UNITED STATES  
NUCLEAR REGULATORY COMMISSION

Subject: DIABLO CANYON POWER PLANT - NRC SPECIAL INSPECTION  
REPORT 05000323/2009009

Report: 05000323/2009009

Facility: Diablo Canyon Power Plant, Unit 2

Attachment 6: Limit Switches

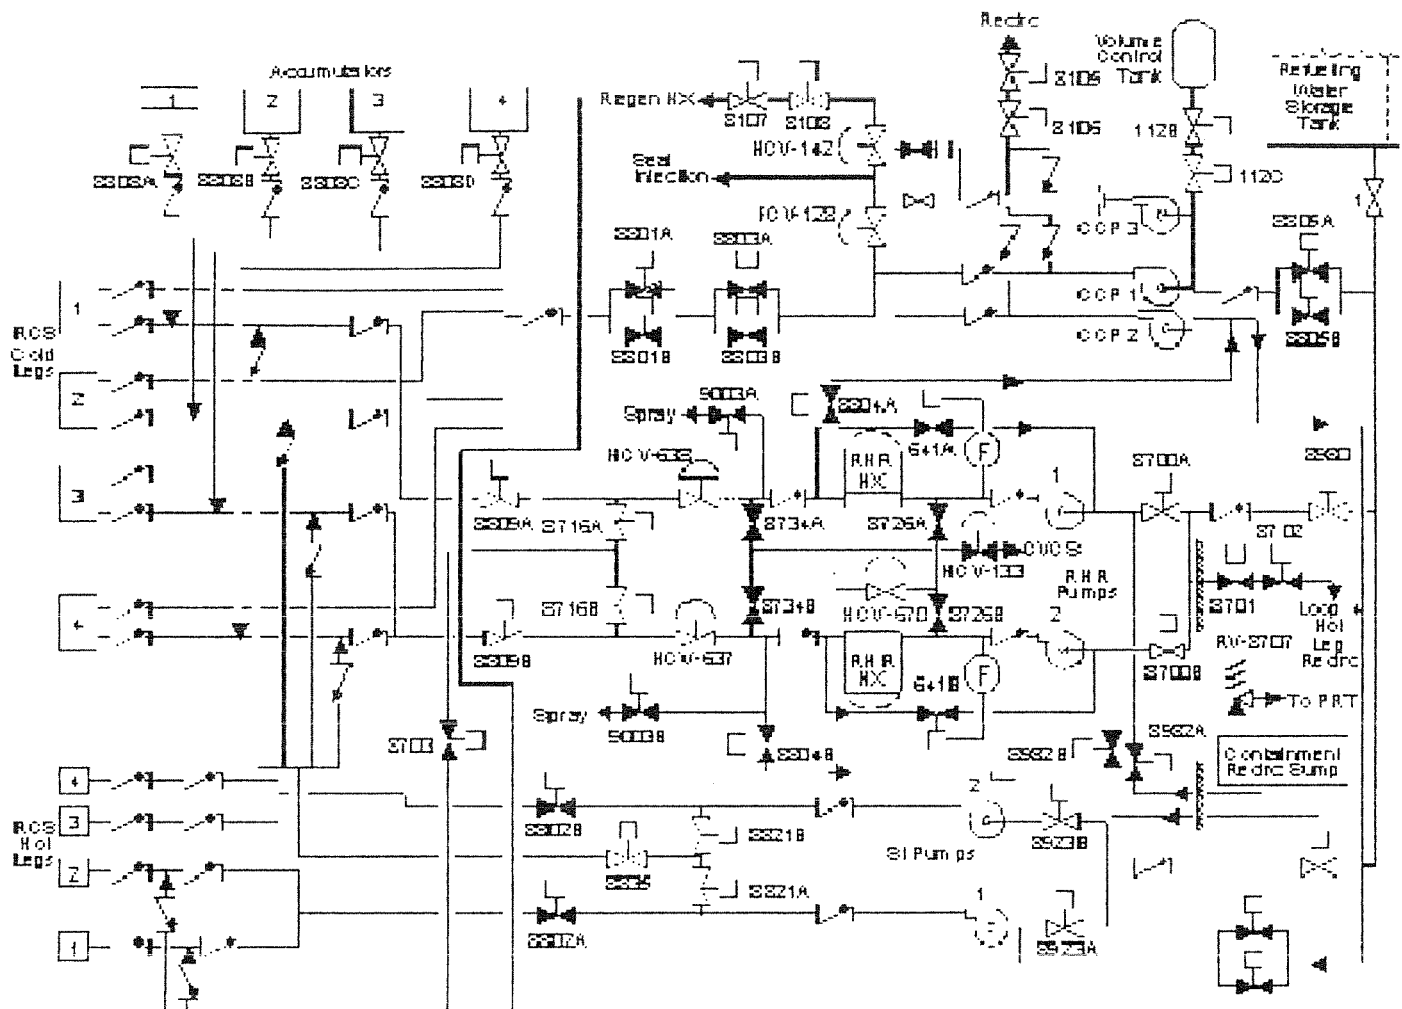
The motor operators for the RHR containment sump valves (SI-2-8982A/B) include a number of limit and interlock switches (see picture in Attachment 6). Four of these switches are operated from mechanical cams or rotors. Each limit switch is actuated following a preset number of cam rotations corresponding to valve stem travel. Rotor #1 controlled the total stroke distance of the valve stem. The valve motor operator stops after the Rotor #1 limit switch engages on the open stroke. The Rotor #3 limit switch was included in a permissive circuit that allowed remote manual operation of Valves SI-2-8804A/B and CS-2-9003A/B from the control room. This interlock is designed to prevent plant operators from opening SI-2-8804A/B or CS-2-9003A/B before the containment sump valves (SI-2-8982A/B) are fully open. The Rotor #3 limit switch must be set to engage before the Rotor #1 limit switch engages for the interlock to operate successfully.
